## Service Information Bulletin

### **SB-10055514-4047**

SUBJECT	DATE
MCM -SPN 3597/FMI 4 - EPA10 - GHG14	March 2014

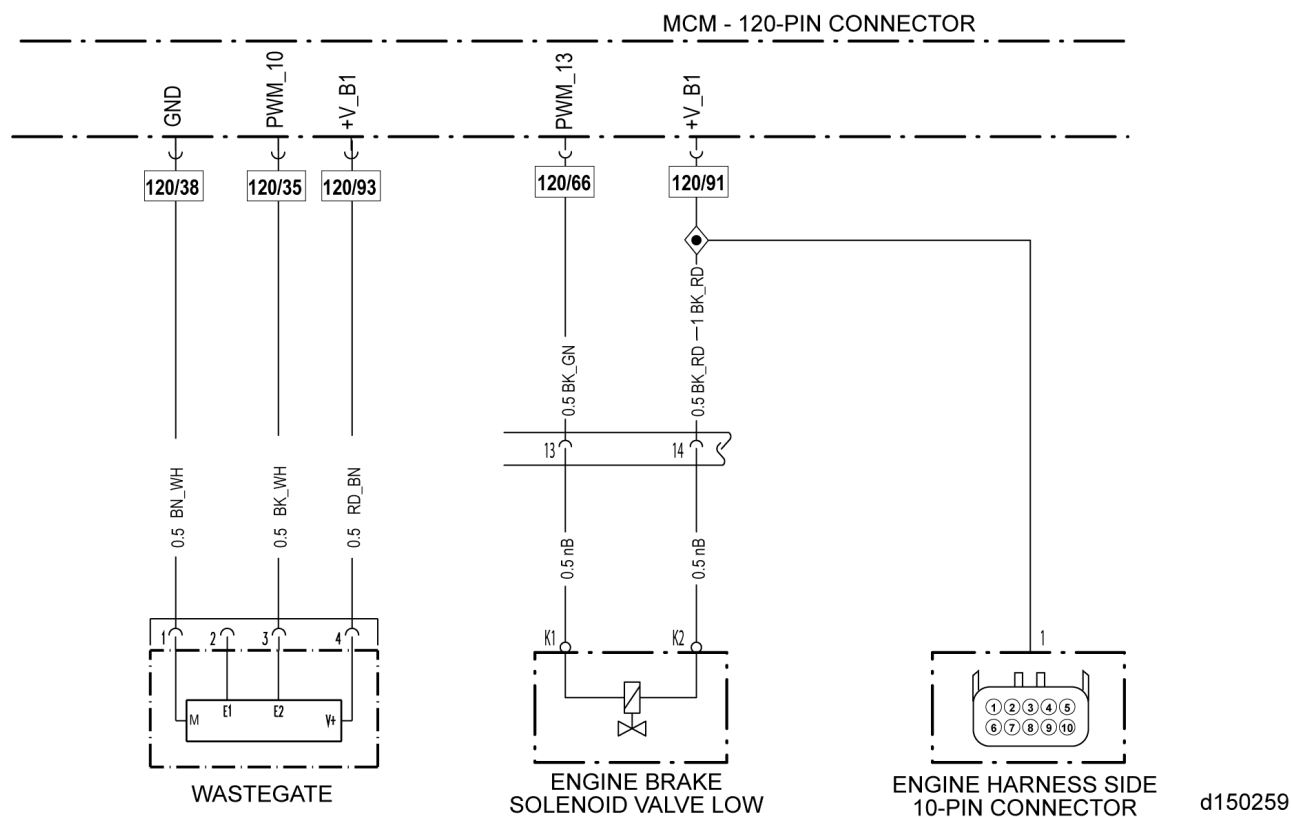
Publication Number / Title	Platform	Section Title	Change
DDC-SVC-MAN-0084	DD Platform	SPN 3597/FMI 4 - EPA10 - GHG14	This is a major update to most of the diagnostics, including the wiring schematic graphic.
